3.2 Elevation Comparison Soap Street
Block B + C

Approved Material Key -
NMA Reference: 128851/
MMC/2020

4.0 Plan Comparisons

4.2 Plan Comparison - First - Fourth Floor Level

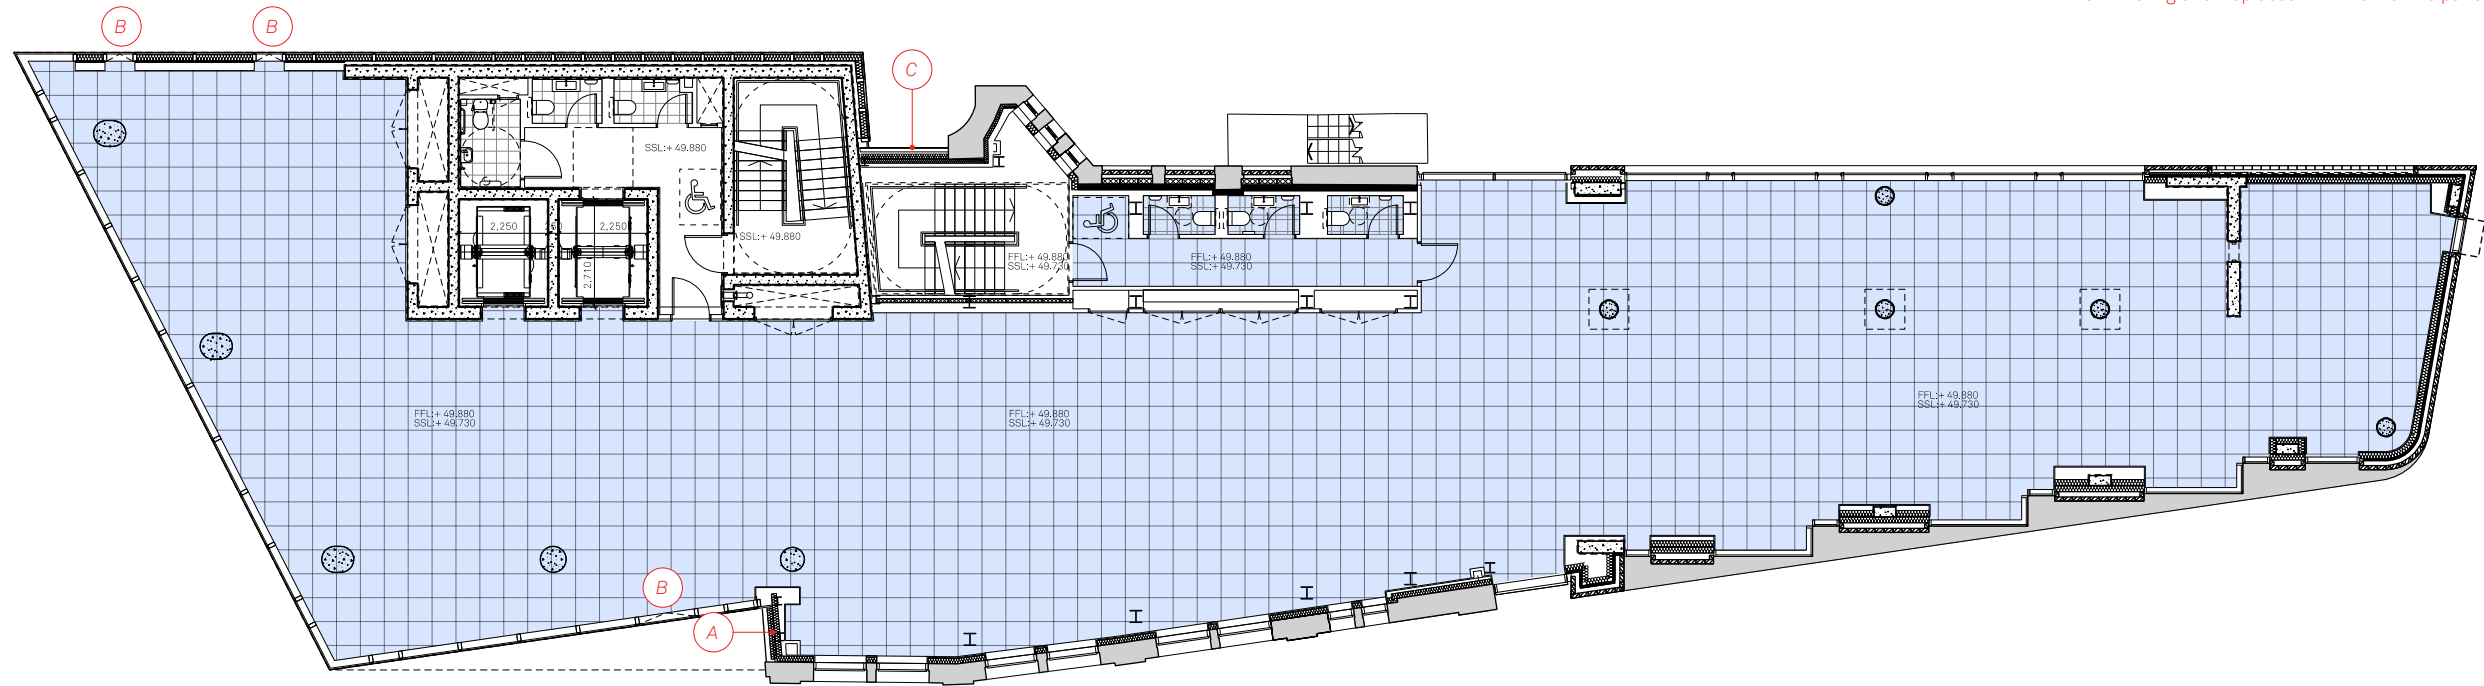
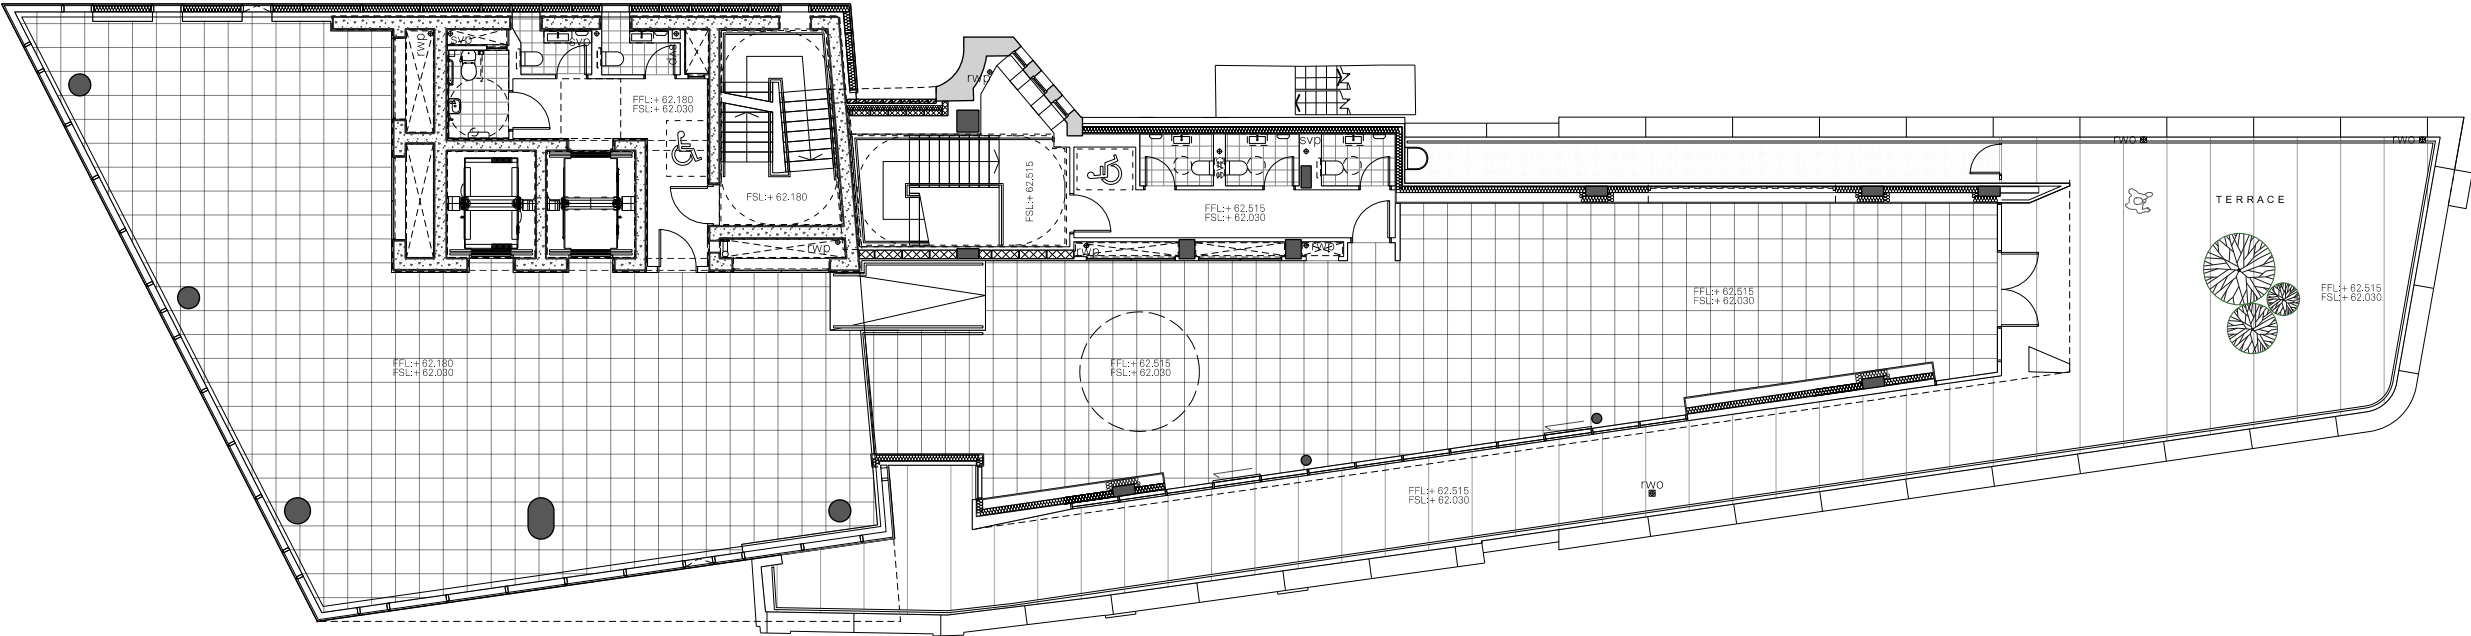
Planning Material change Key

- A - Existing brick replaced with Dark Grey PPC panel. Module size TBC
- B - Glazed AOV added
- C - Existing brick replaced with Bronze PPC panel. Module size TBC

4.3 Plan Comparison - Fifth Floor Level

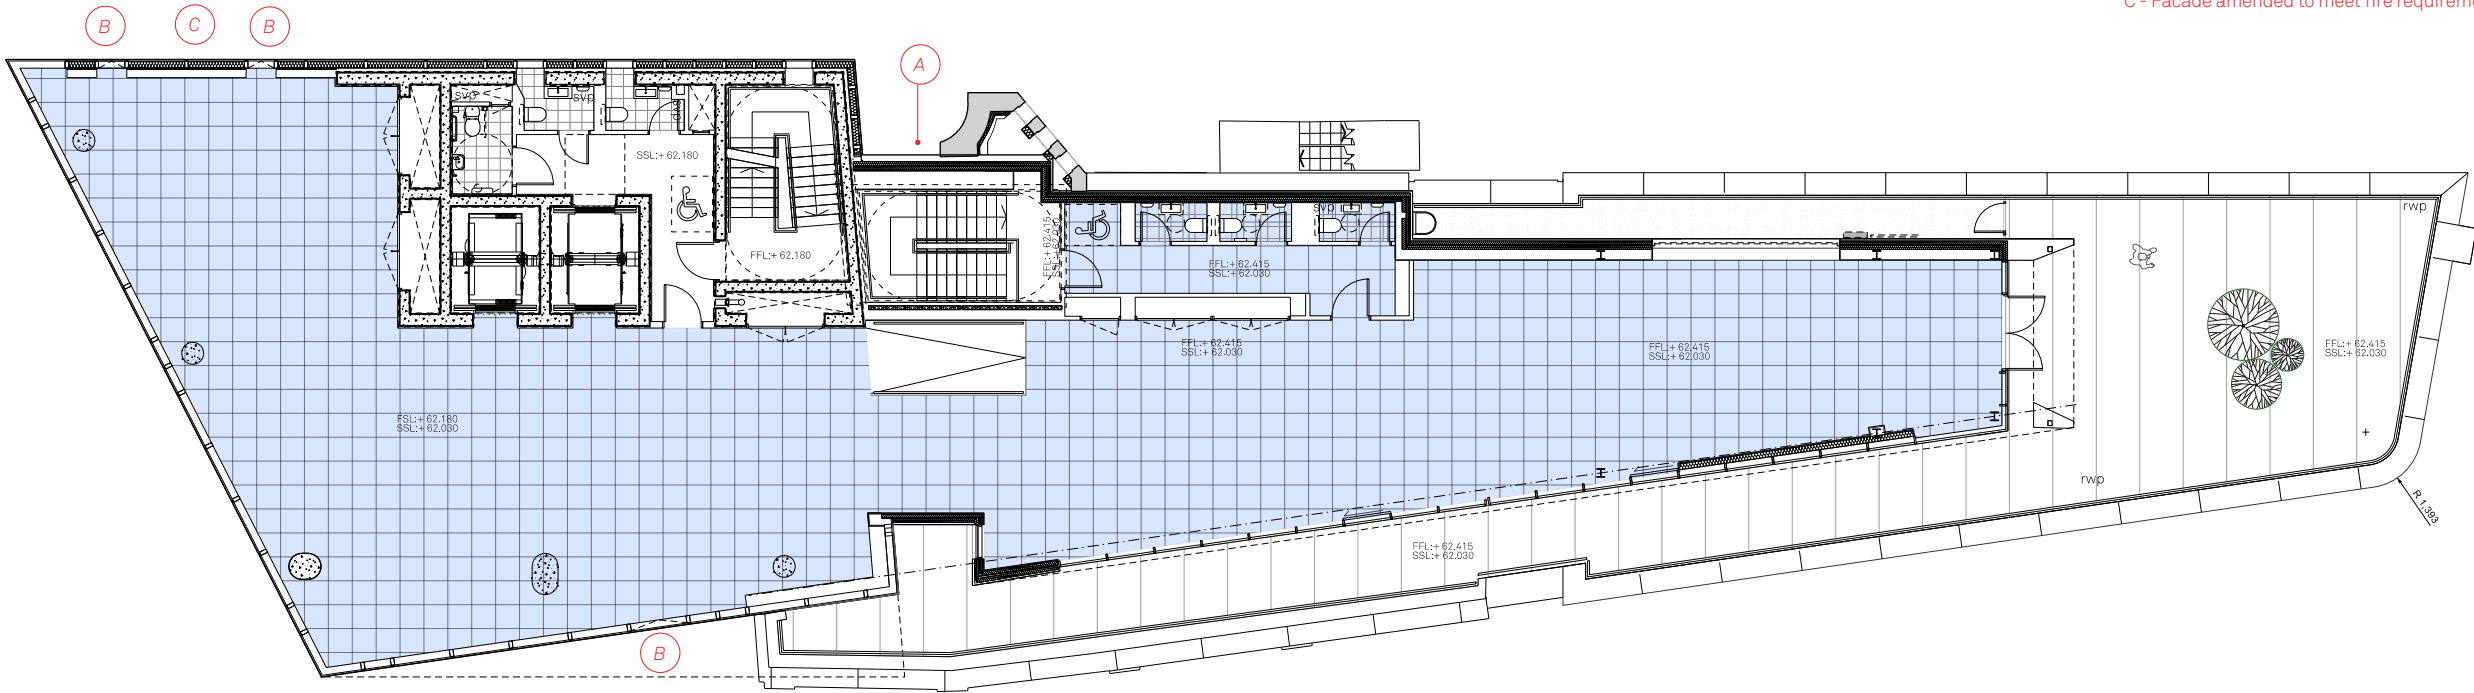
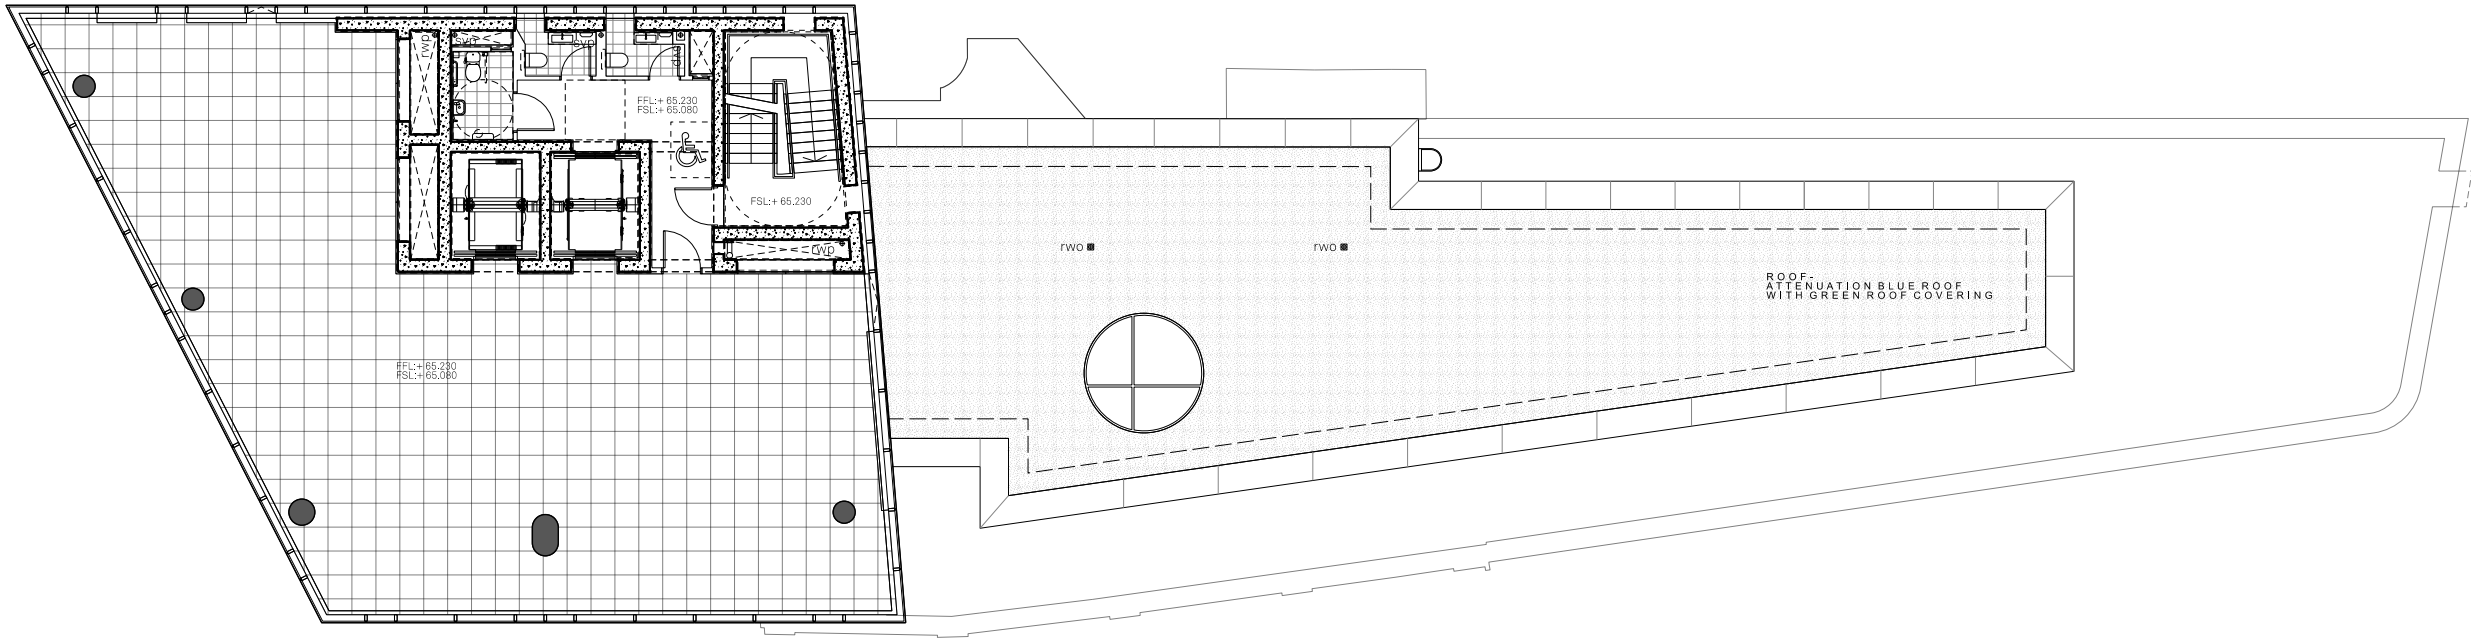
Planning Material change Key

- A - Existing brick replaced with Bronze PPC panel. Module size TBC
- B - Glazed AOV added
- C - Facade amended to meet fire requirements

4.4 Plan Comparison - Sixth Floor Level

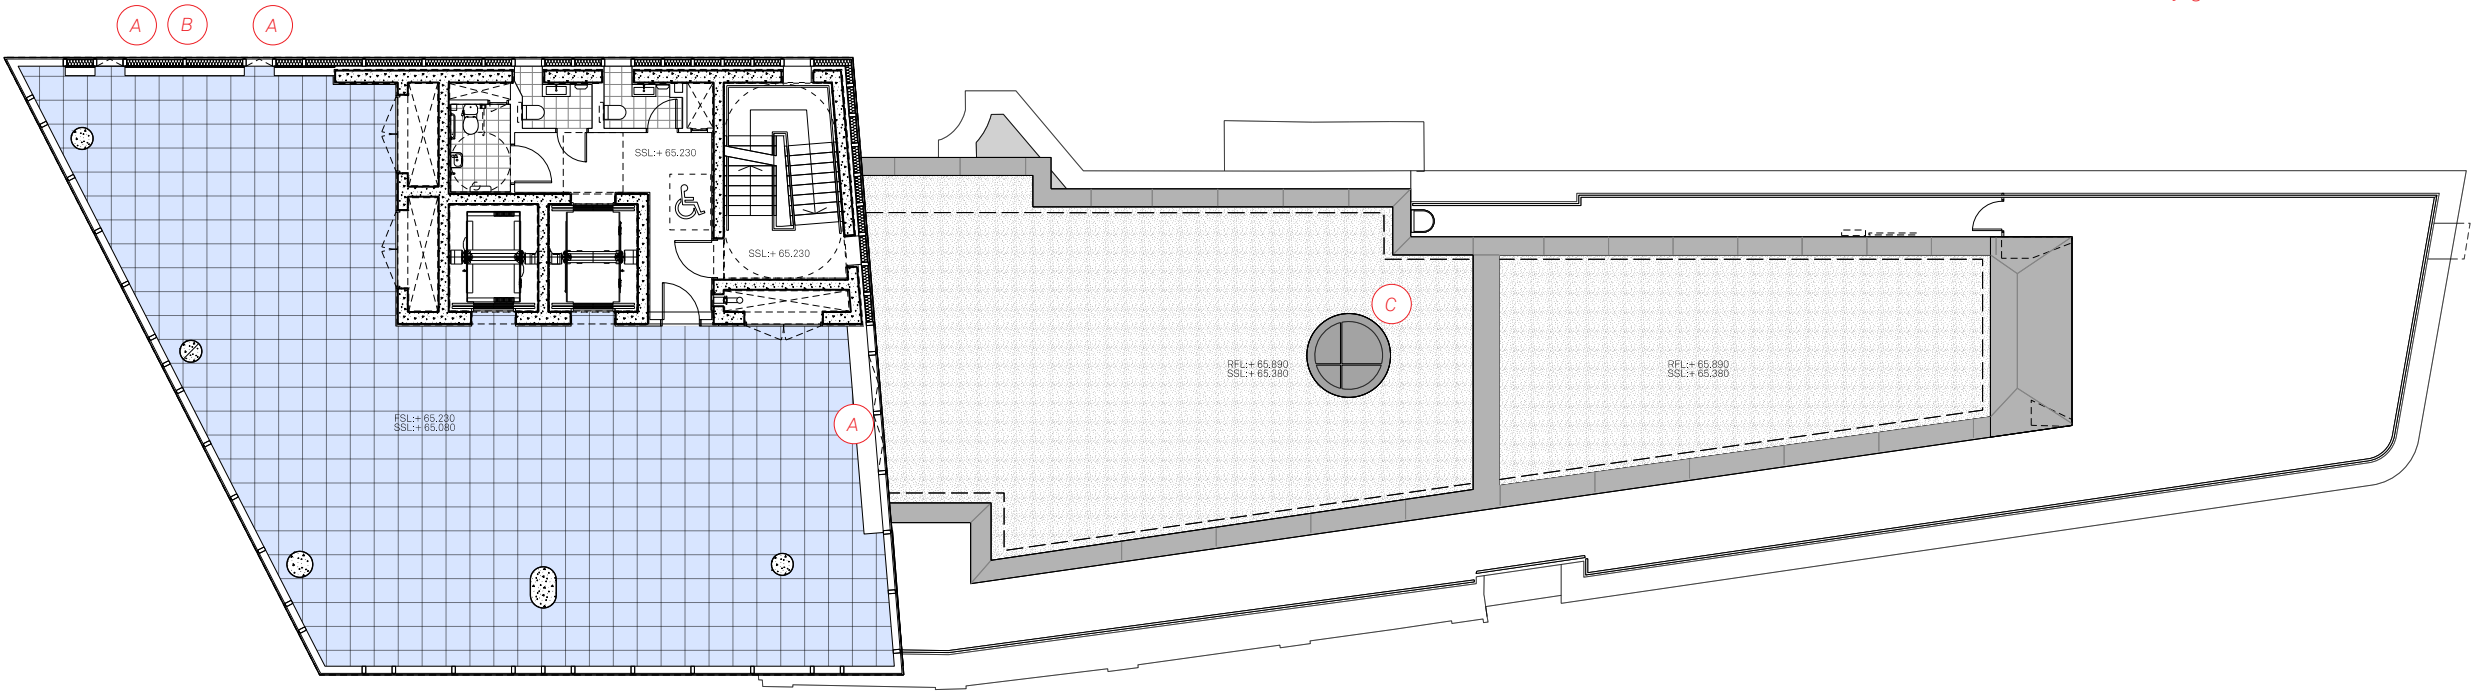
Planning Material change Key

- A- Glazed AOV added
- B - Facade amended to meet fire requirements
- C - Skylight relocated
